In the Claims:

REMARKS

B. Drawings

FIG. 1

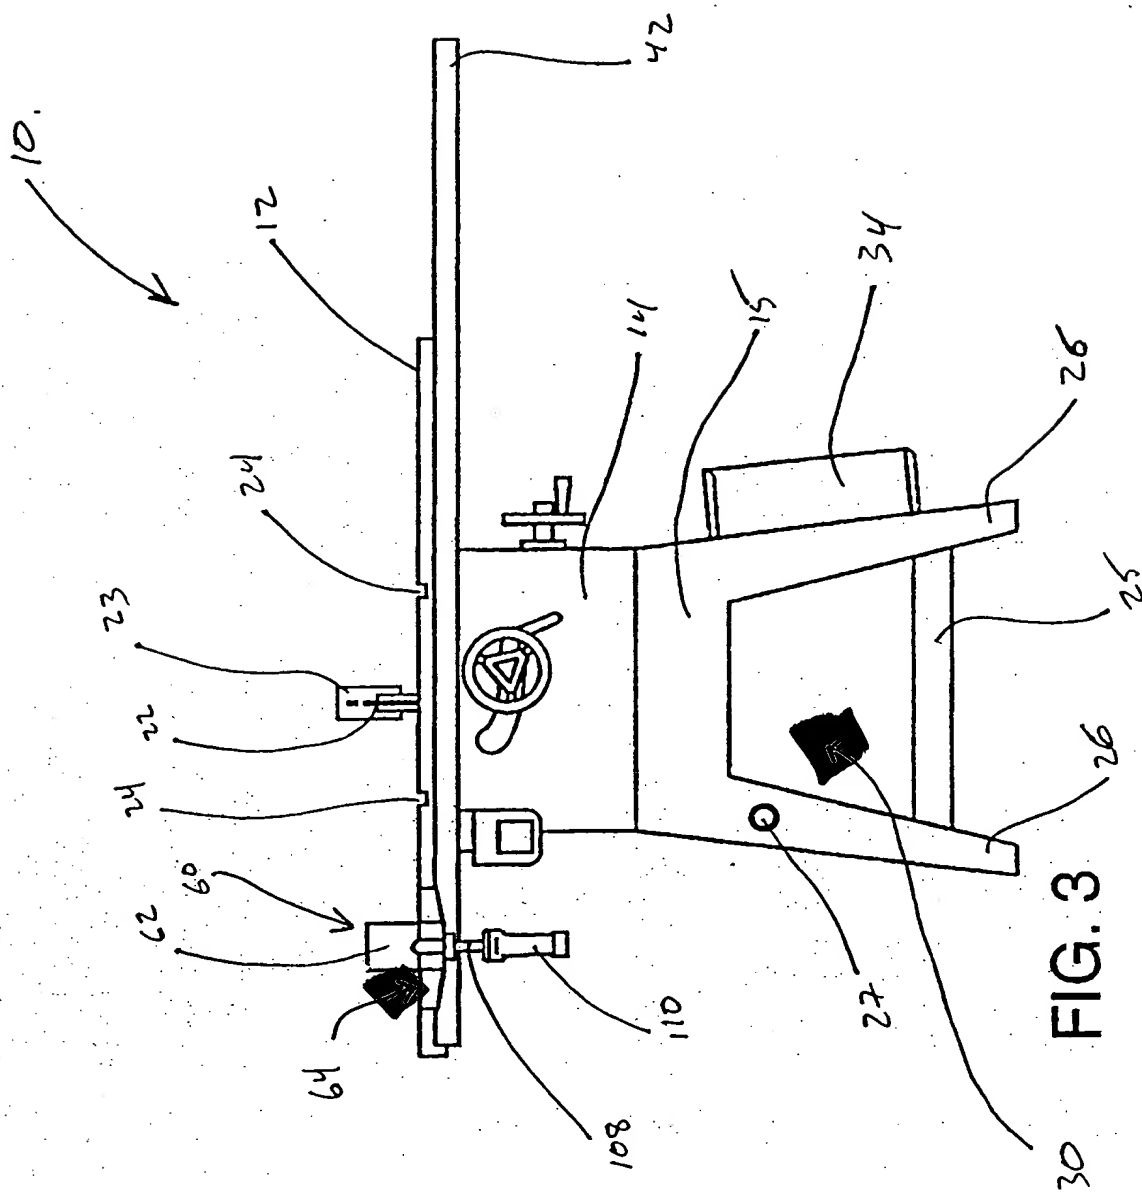
Figure 1: Reference number "64" lead line amended to terminate with an arrow.

FIG. 4

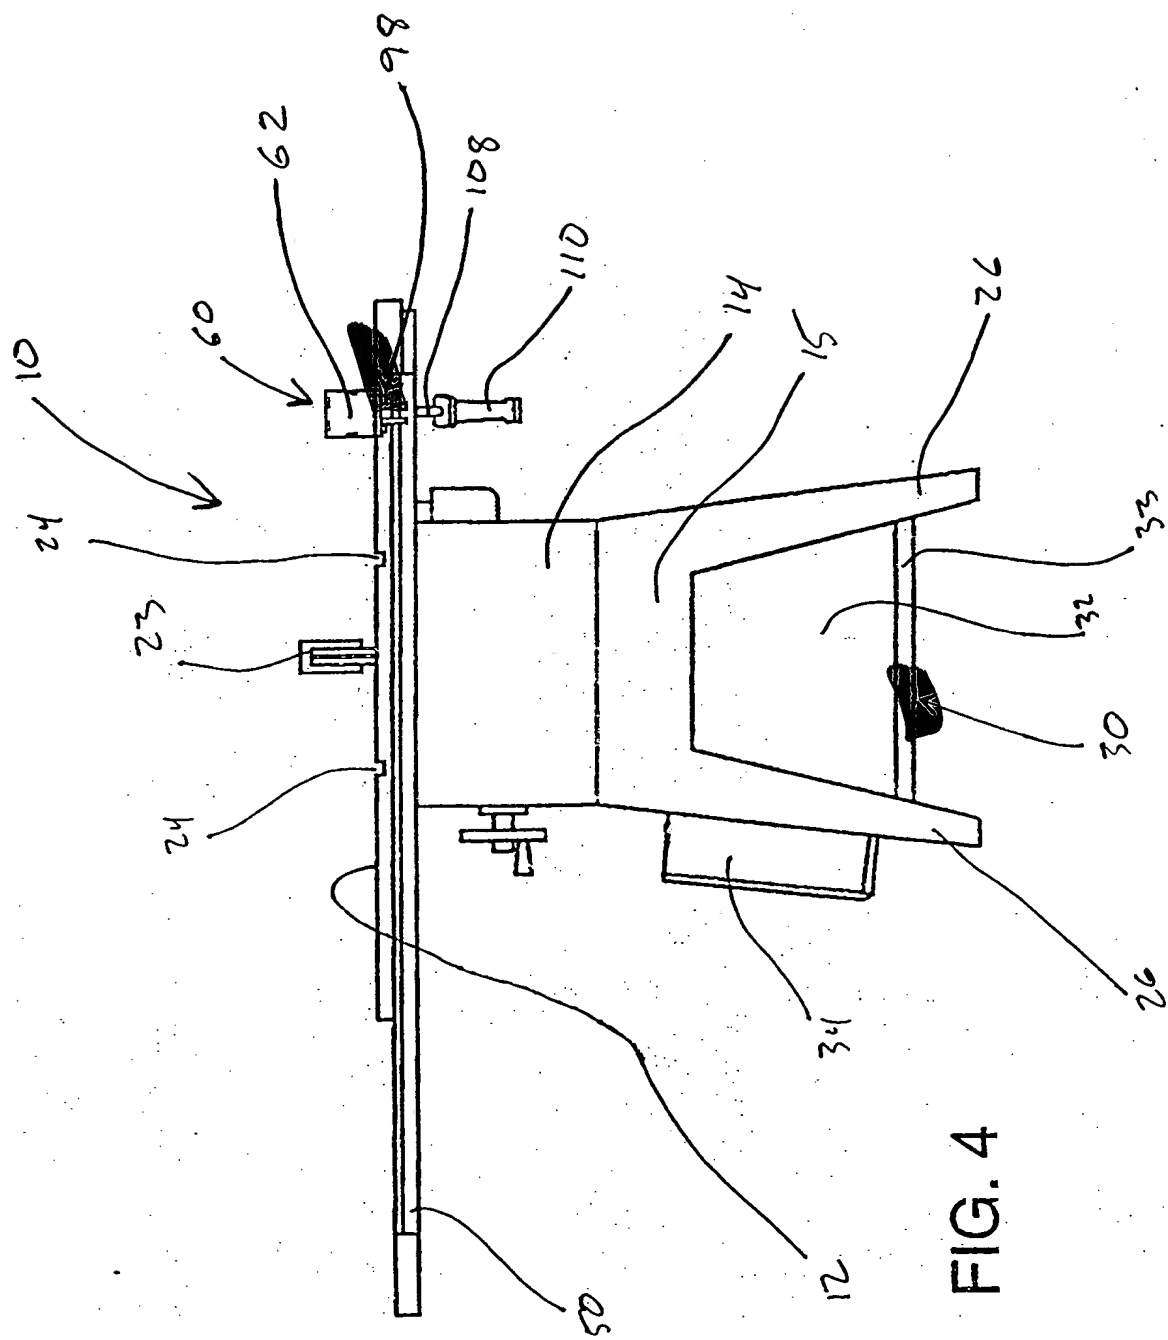
Figure 4: Reference number "98" lead line amended to terminate with an arrow.

Reference number "30" lead line amended to terminate with an arrow.

FIG. 5

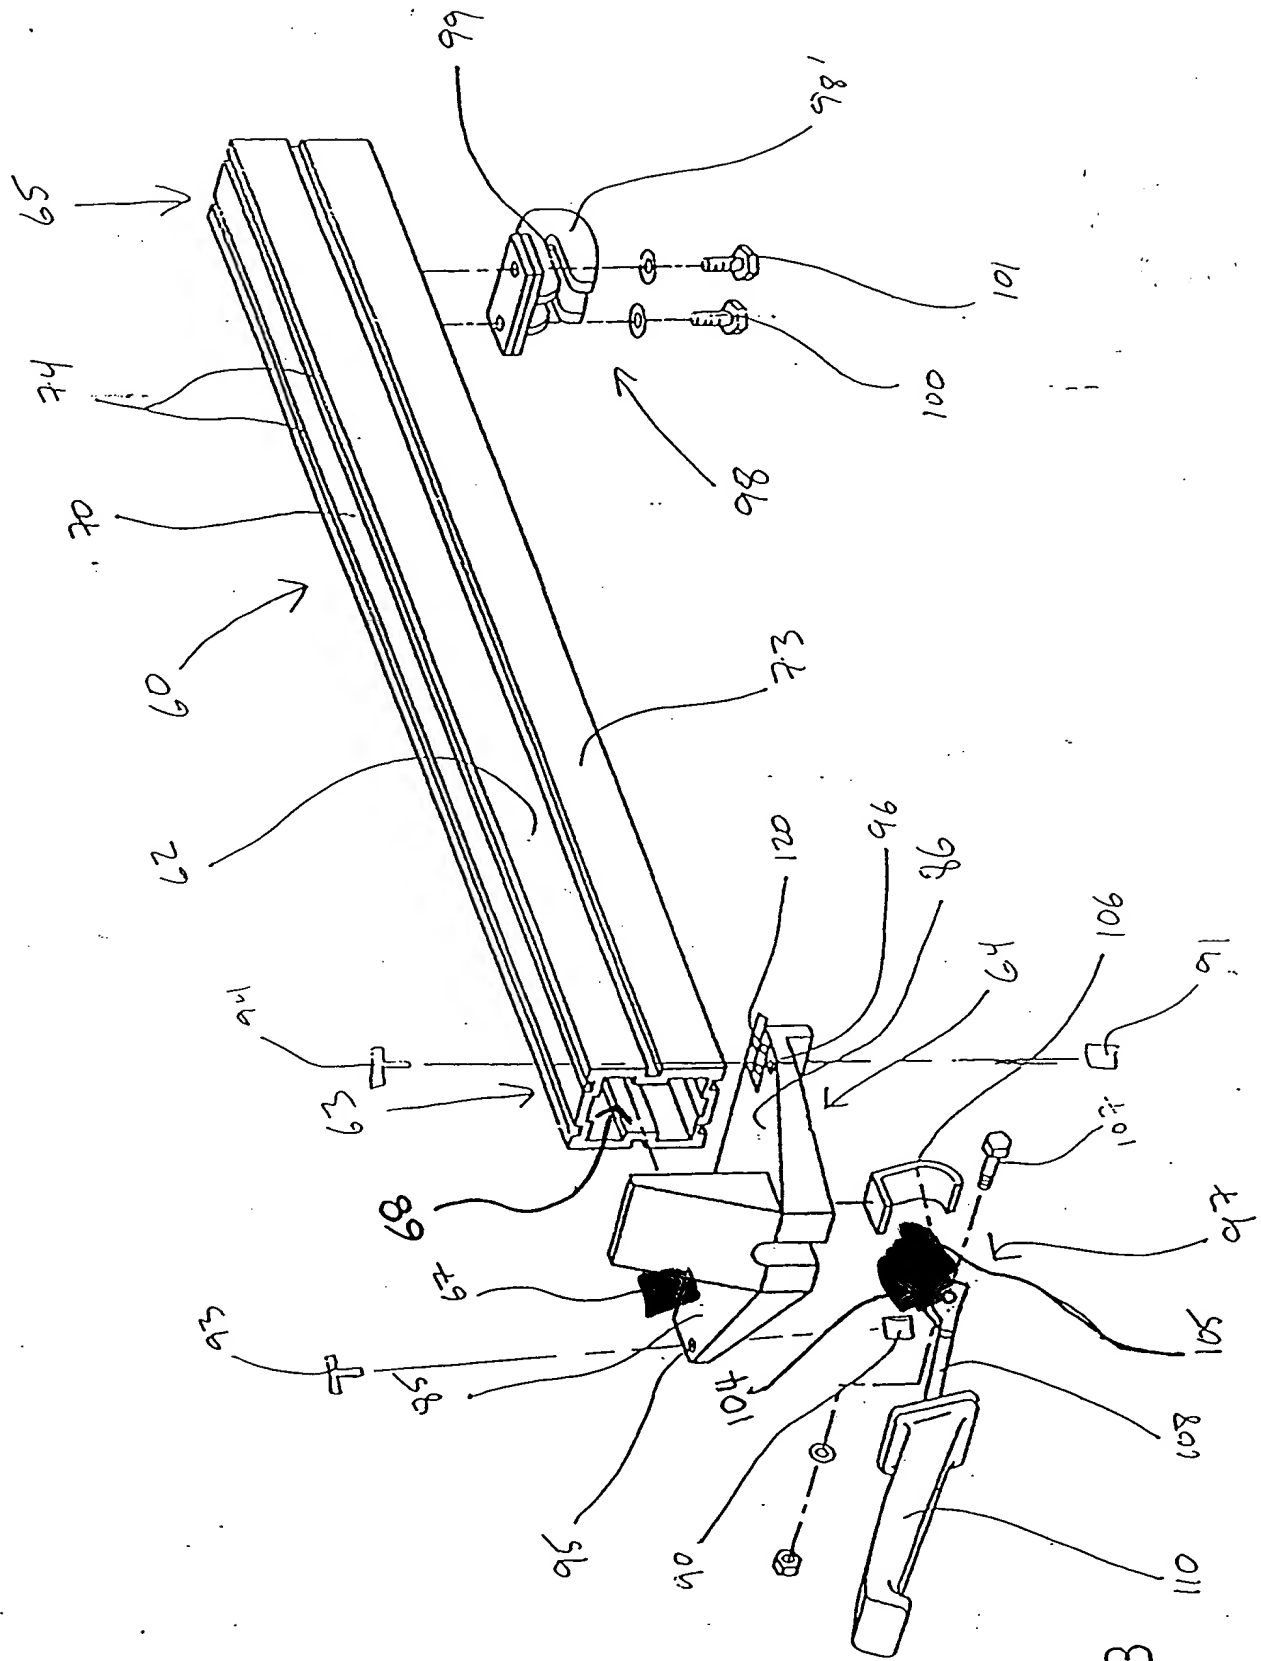
Figure 5: Reference number "98" lead line amended to terminate with an arrow.

Reference number "30" lead line amended to terminate with an arrow.

Reference number "12" and reference number "12" lead line deleted.

Reference number "105" replaced with reference number "107" to properly show the element.

Reference number "64" lead line amended to terminate with an arrow.

FIG. 14

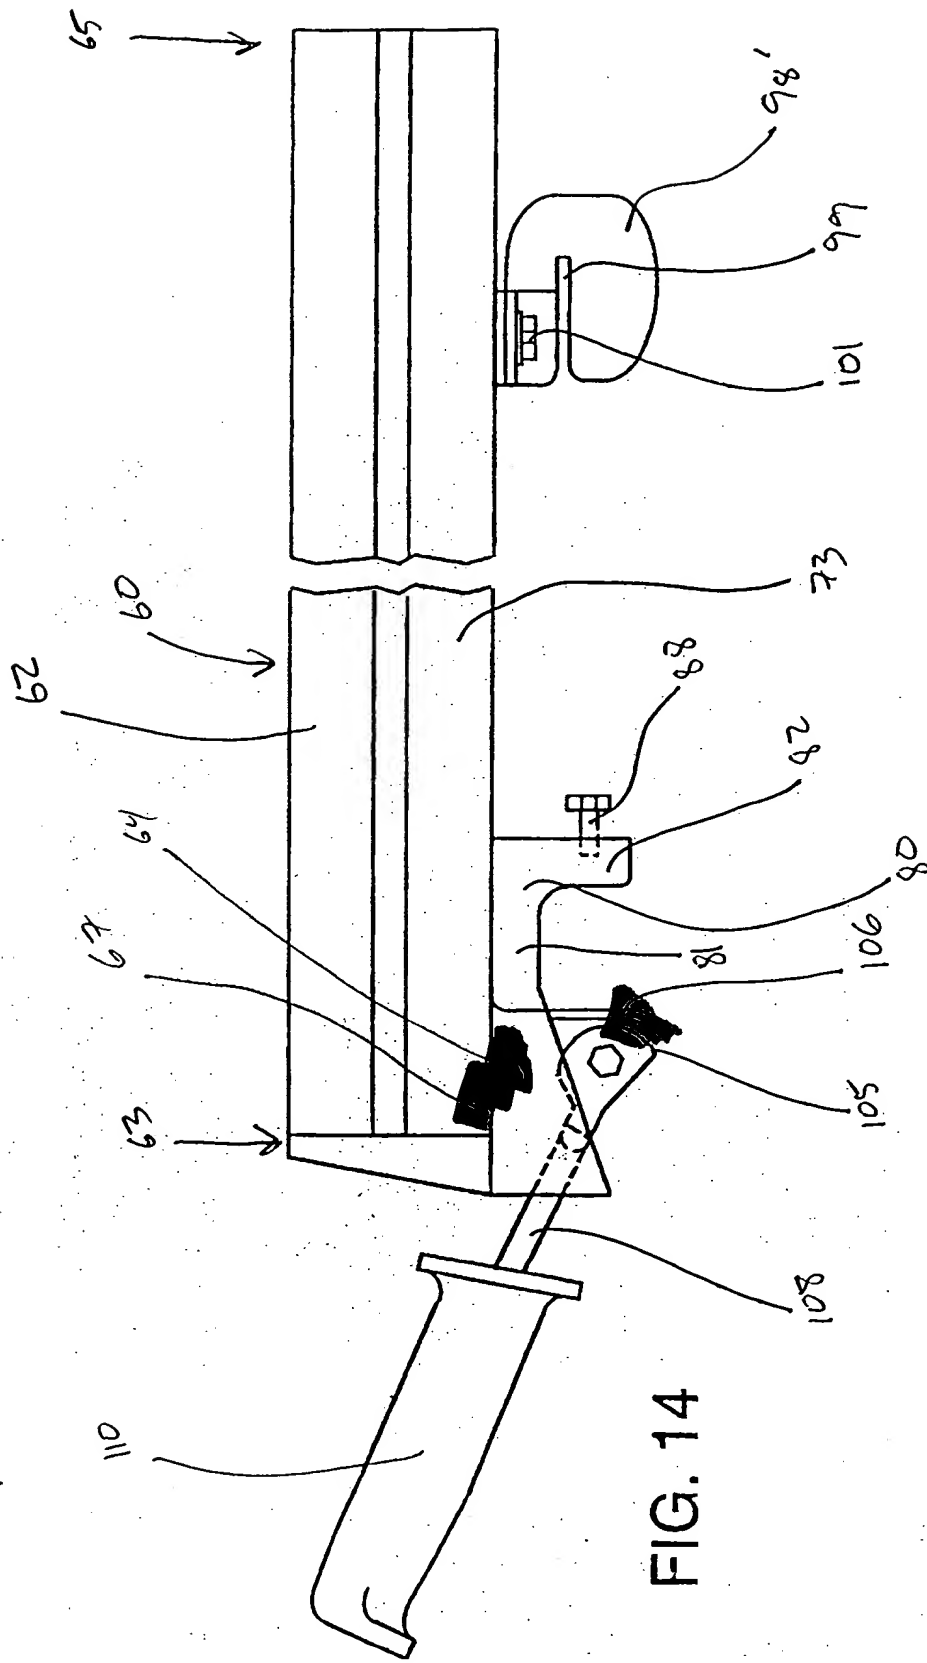
Figure 14: Reference number "67" lead line amended to terminate without an arrow.

Reference number "64" lead line amended to terminate with an arrow.

Reference number "105" lead line redirected to point to the proper element surface.
